ADDENDUM

PROJECT: Jefferson Community Health Center
Patient Wing and Administration Renovation
Fairbury, Nebraska

AD-2

DATE ISSUED: Friday, January 25, 2013

30 OPEN DRAWER CABINET
Scale: 1 1/2" = 1'-0"

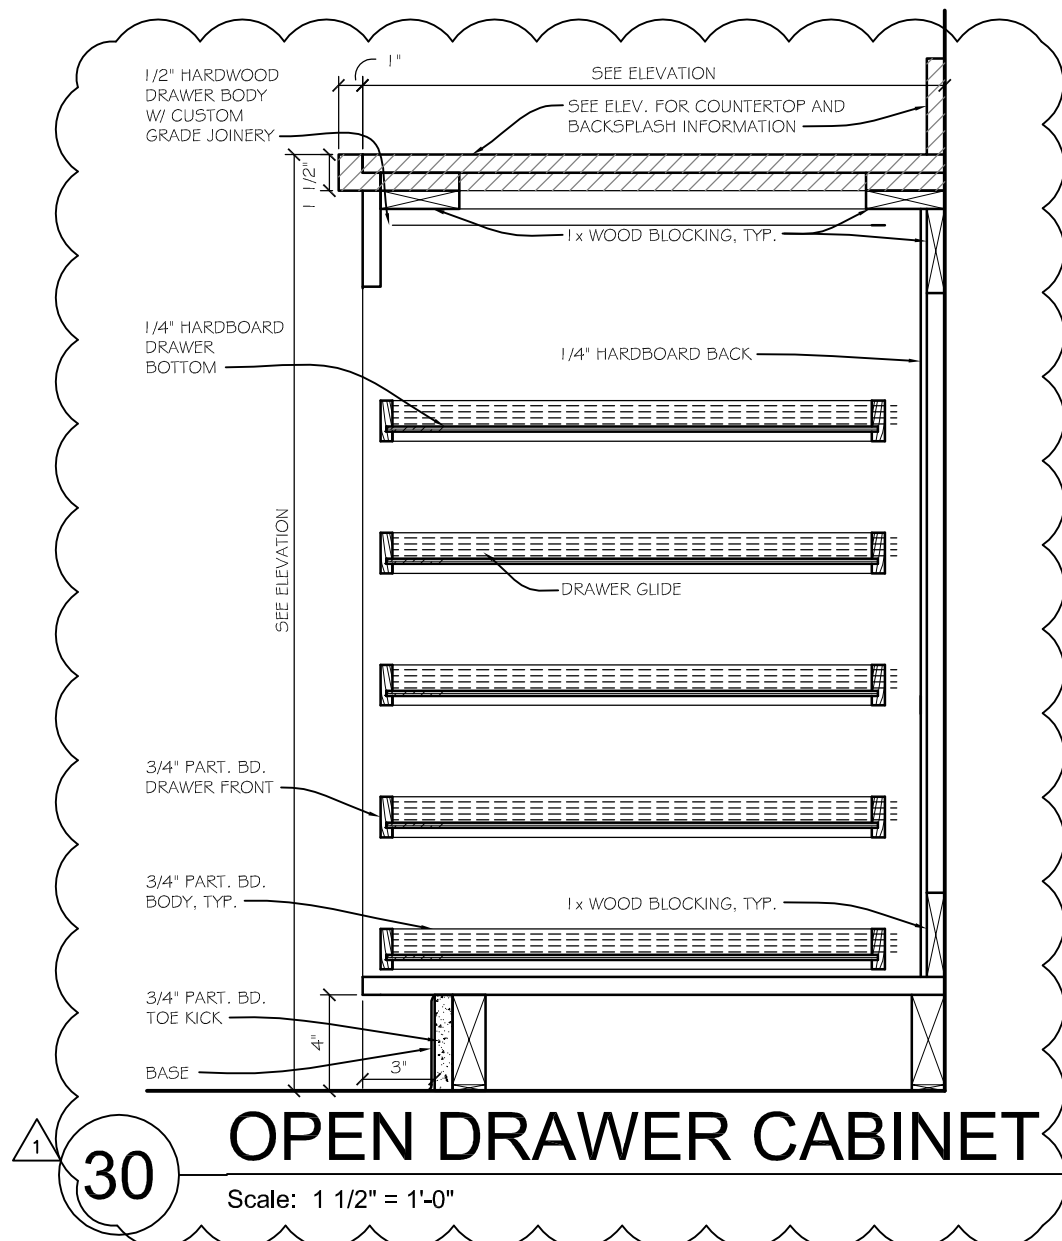
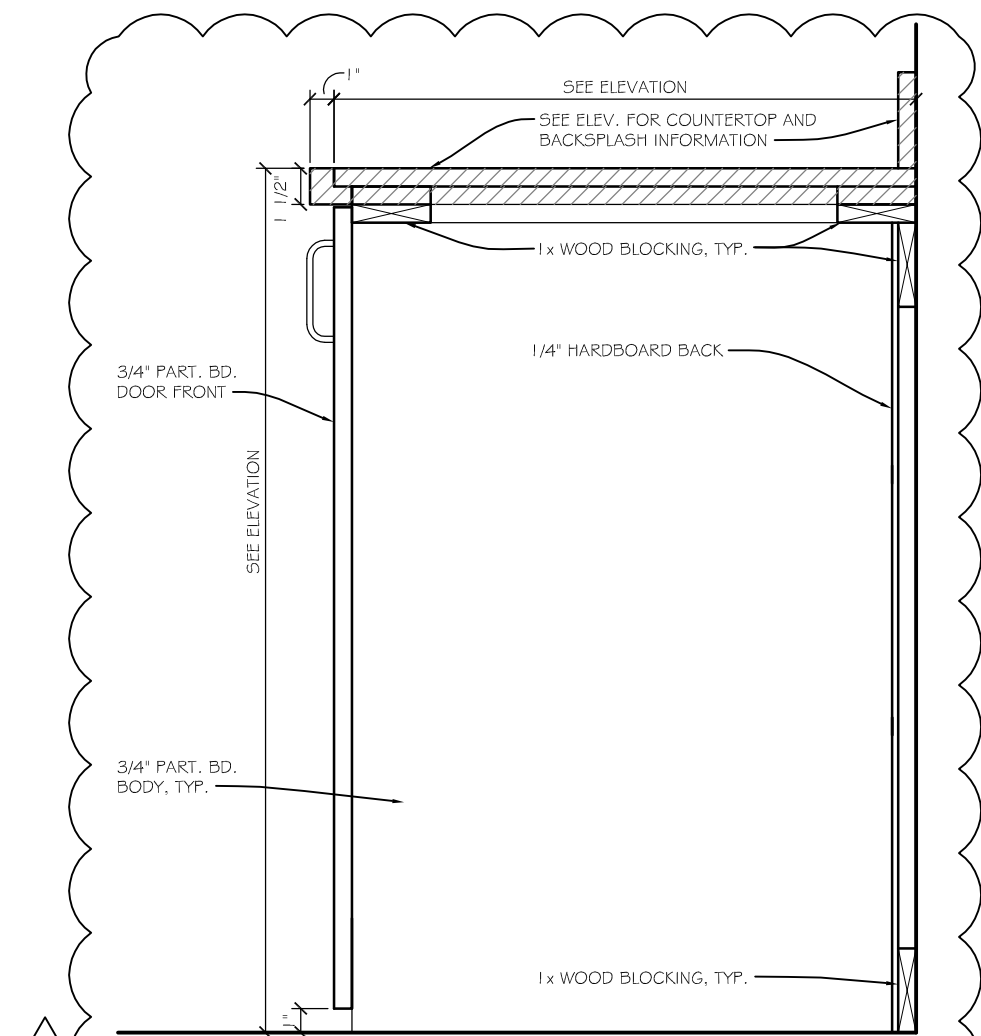
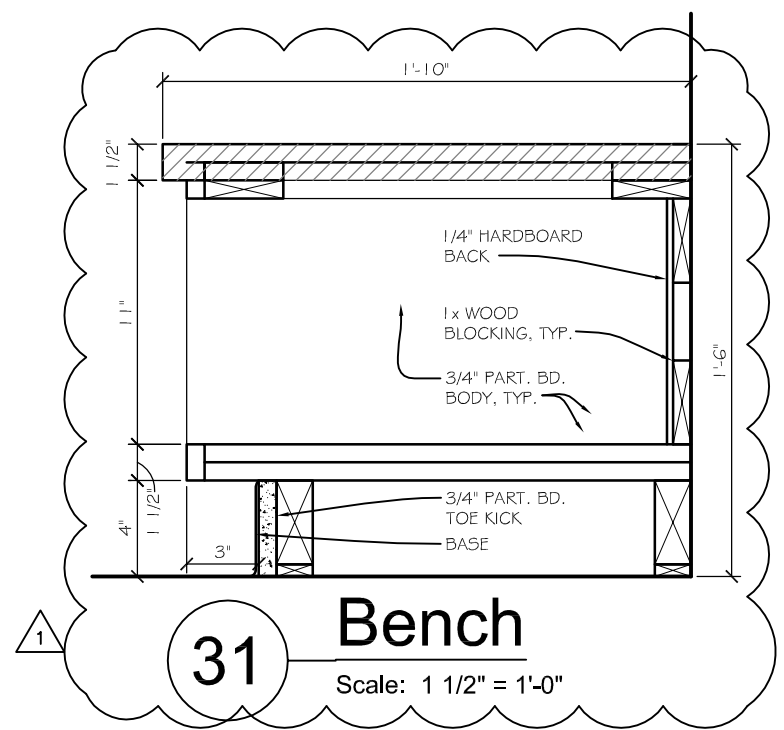
In reference to **Sheet A-502**, see attached Sheet A-502.1 for additional casework details.

**Main Level Area A HVAC
 Demolition Plan Phase 2 -
 AD-2**

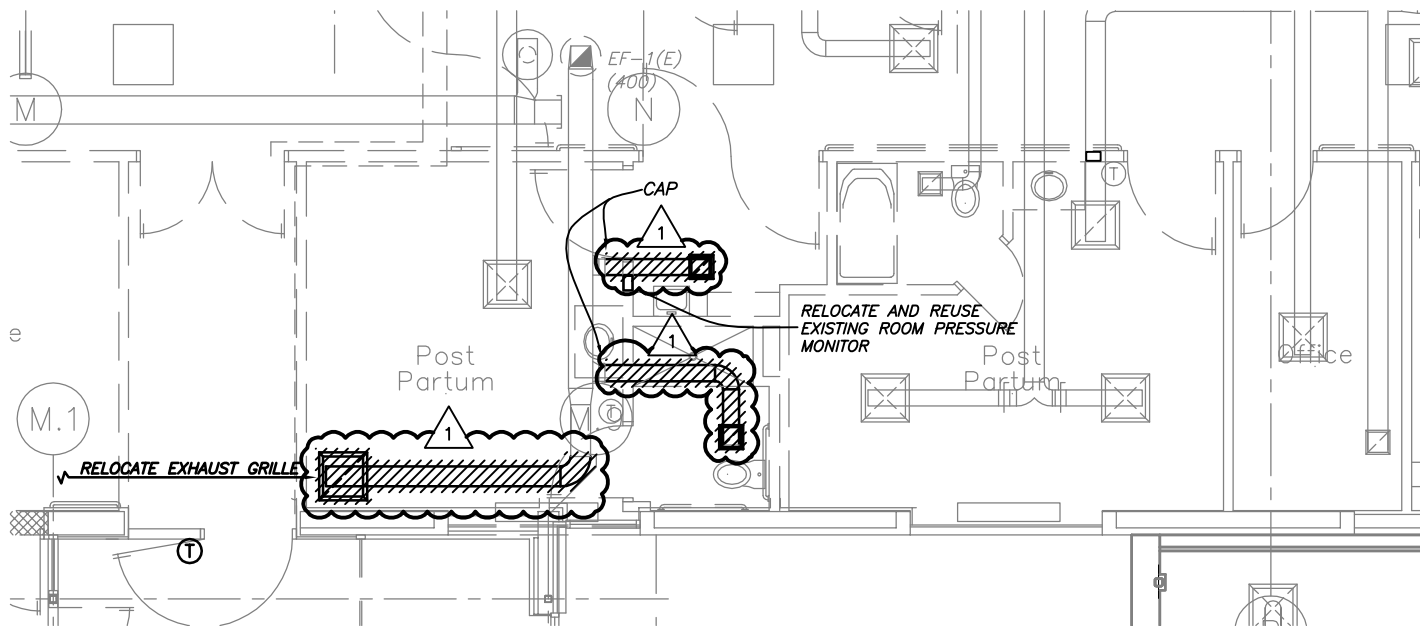
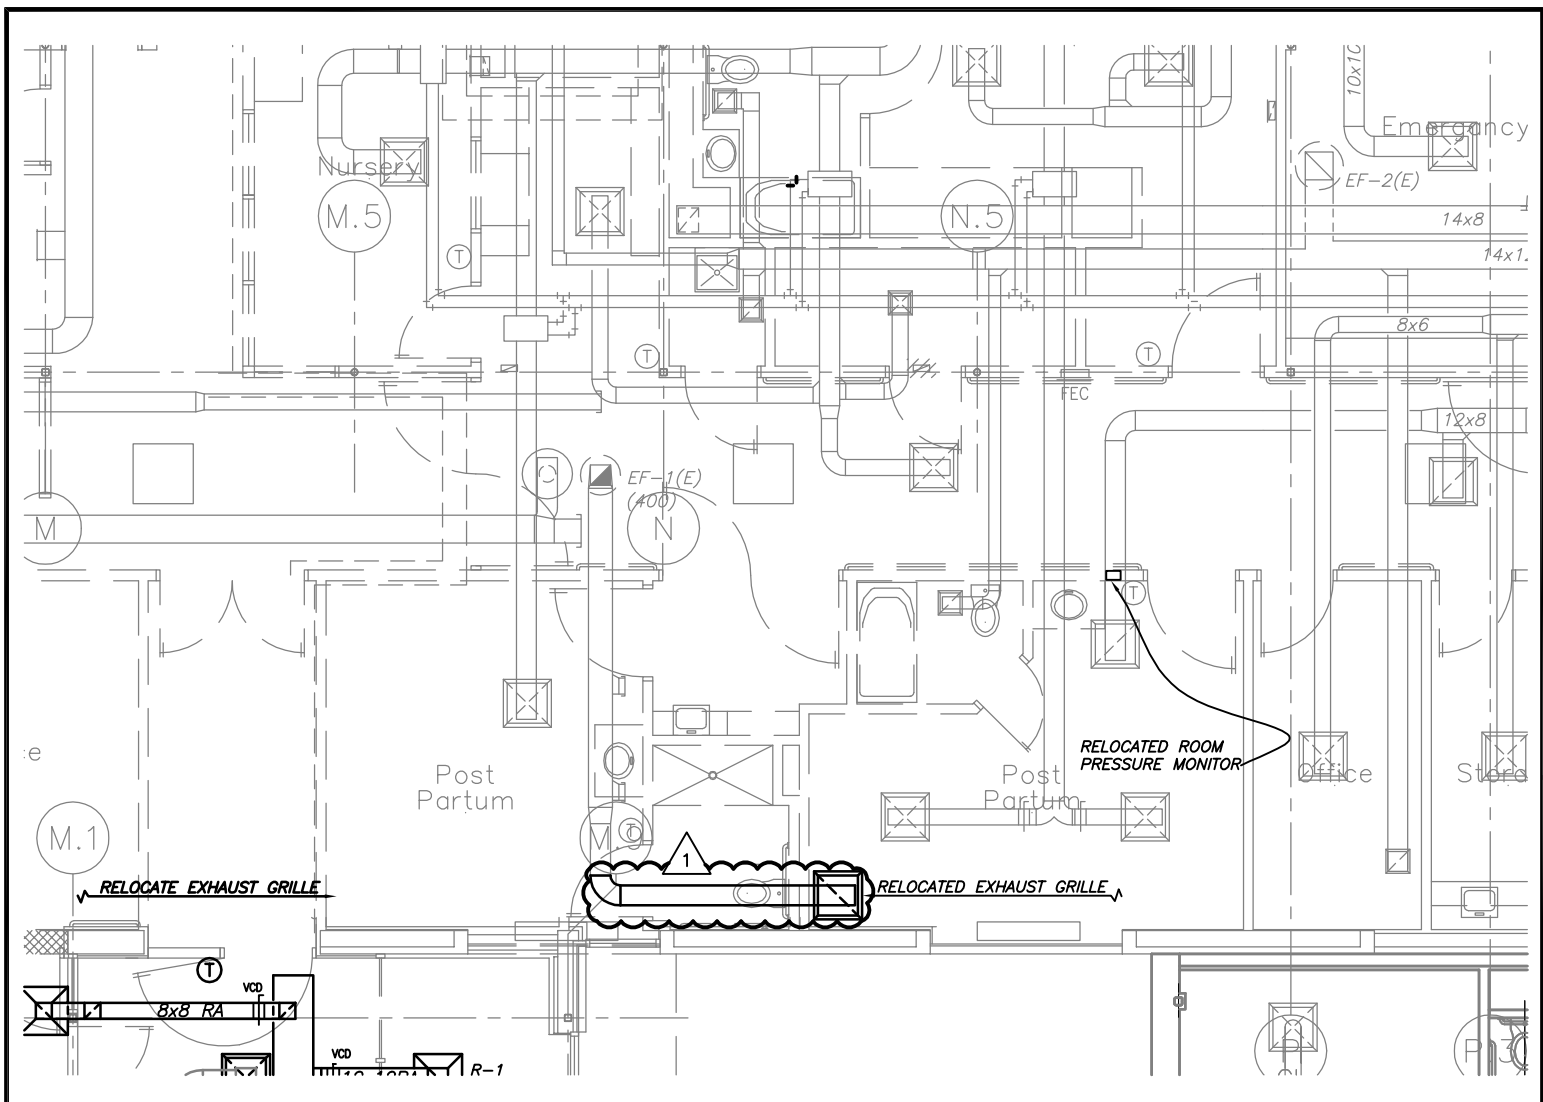
In reference to **Sheets M-113, and M-114**, The existing post-partum room that is being used as an Airborne Infection Isolation (All) room will be demolished during phase 2. The adjacent post-partum room shall be used as the All room during phase 2 until the new All room is constructed. The existing exhaust grilles and ductwork shall be demolished and temporarily installed as shown in attached Sheet M-113.1 and Sheet M-114.1. The existing room pressure monitor serving the All room shall be relocated to the temporary room as required.

Main Level Area A HVAC Plan
Phase 2 - AD-2

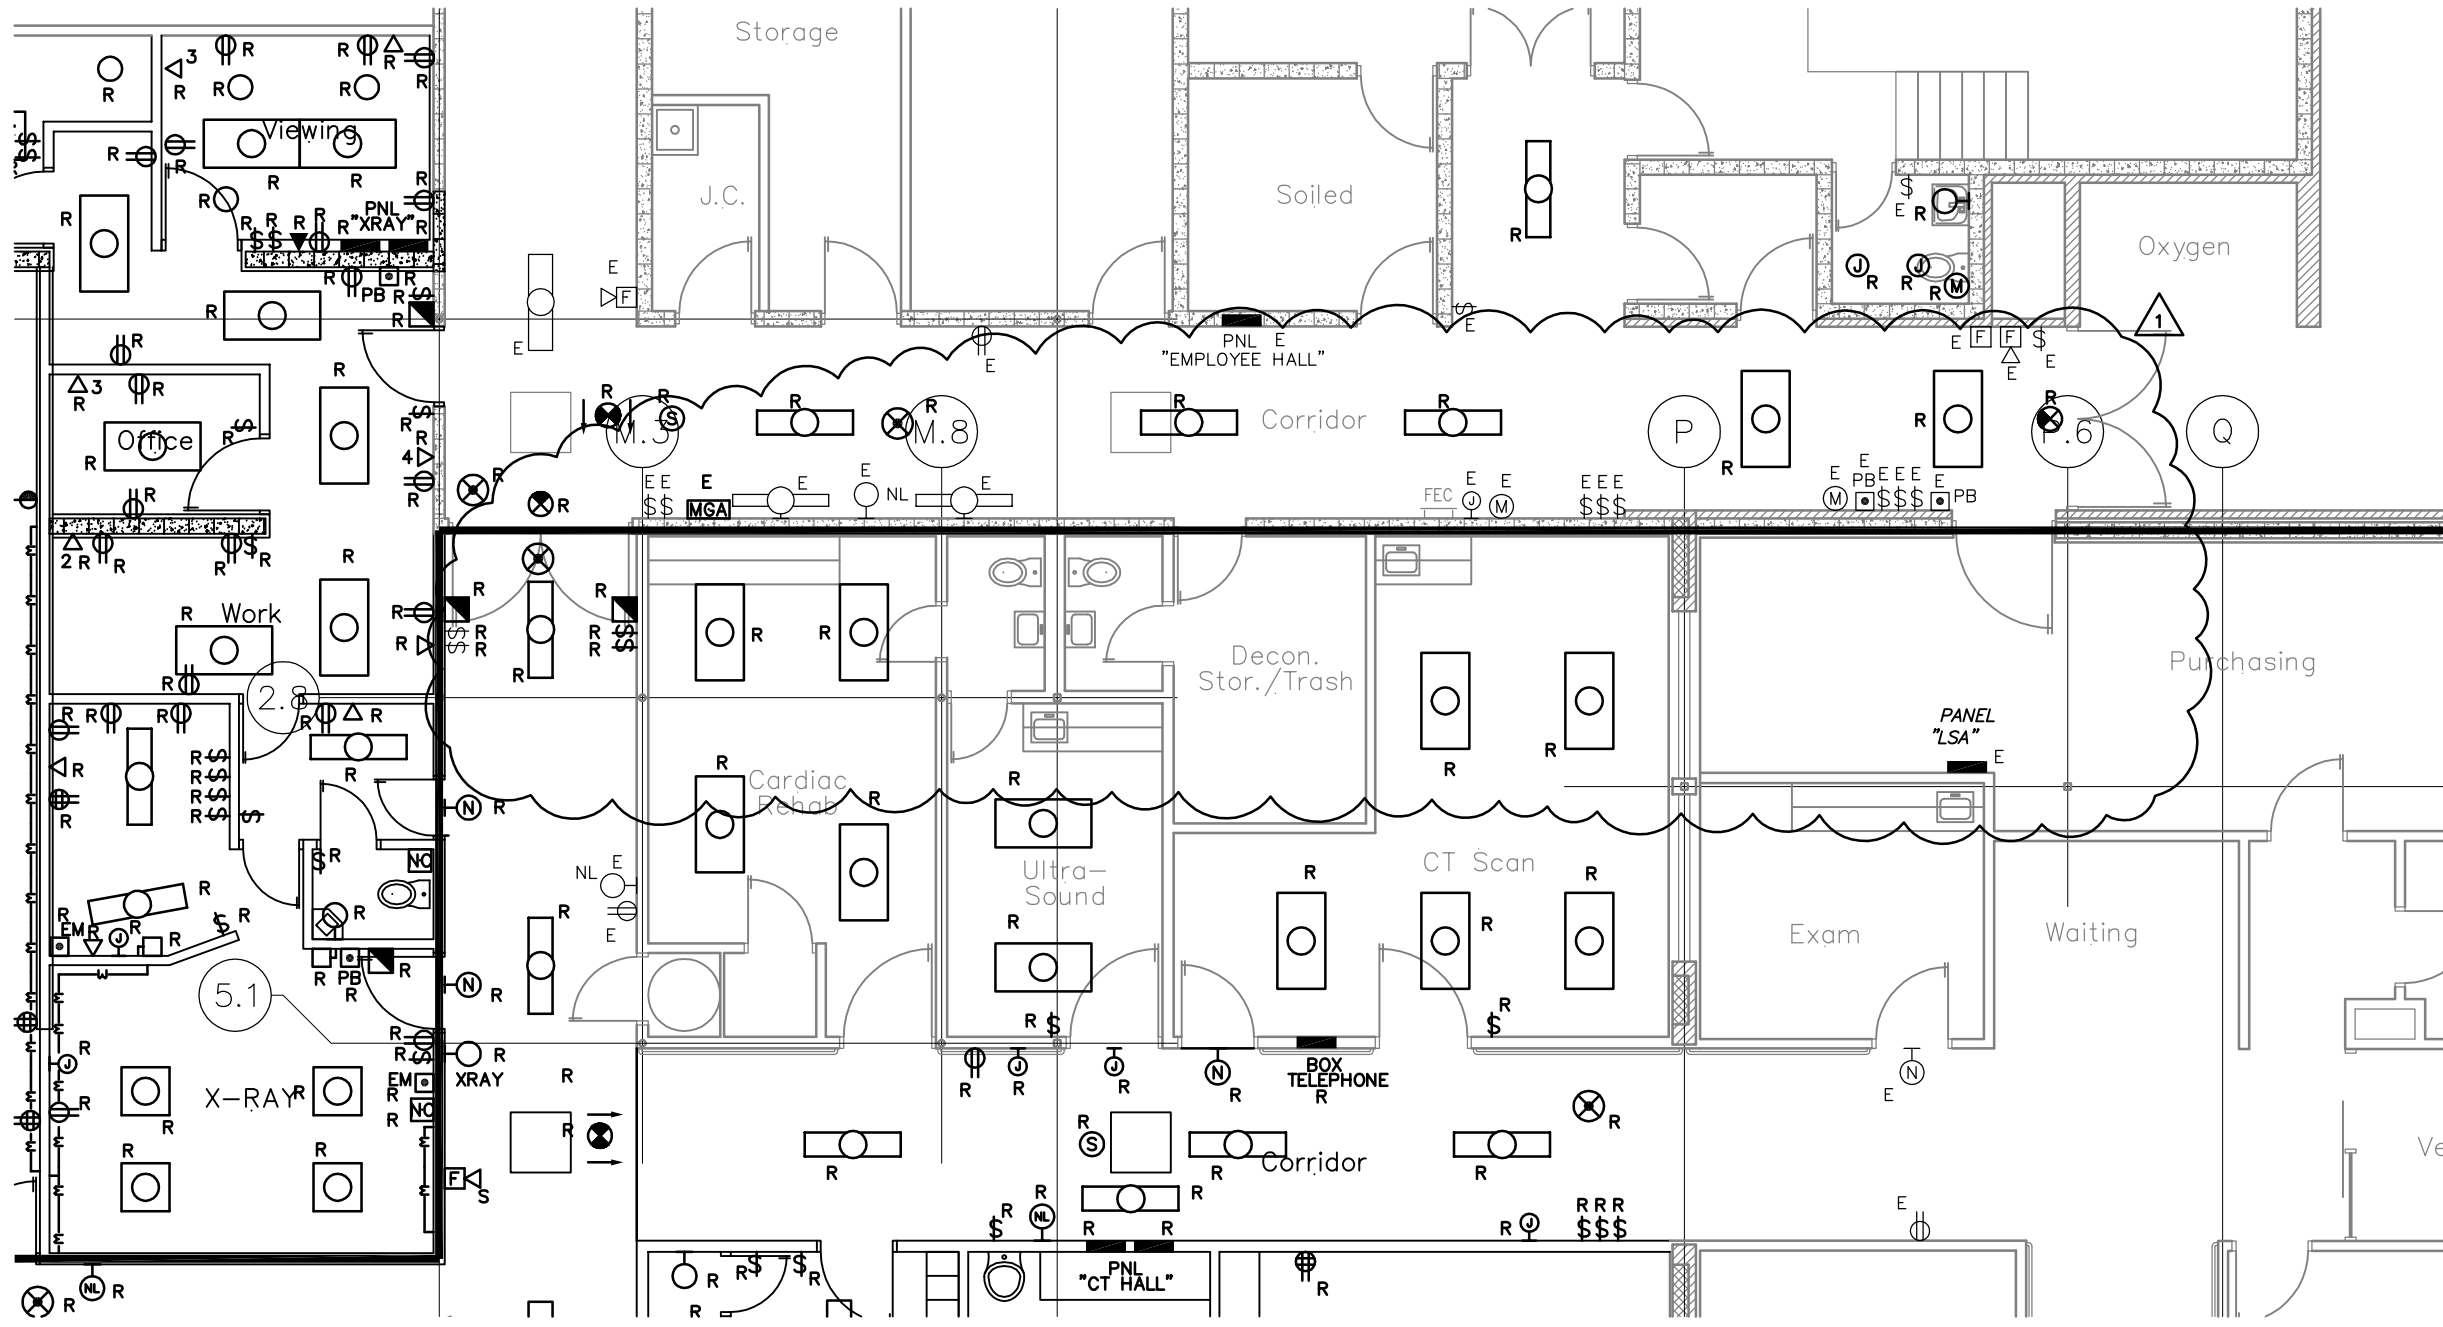
In reference to **Sheet M-113, and M-114**, Demolish the existing exhaust fan located in the restroom off of the boiler room. Provide a new exhaust fan EF-8 and discharge to the outdoors out of the building side wall above the oxygen storage area. The new EF-8 exhaust fan shall be Greenheck model SP-A70, ceiling mounted exhaust fan. Provide model WC hooded wall cap for exhaust termination, and paint to match building exterior. See attached sheet M-114.2.
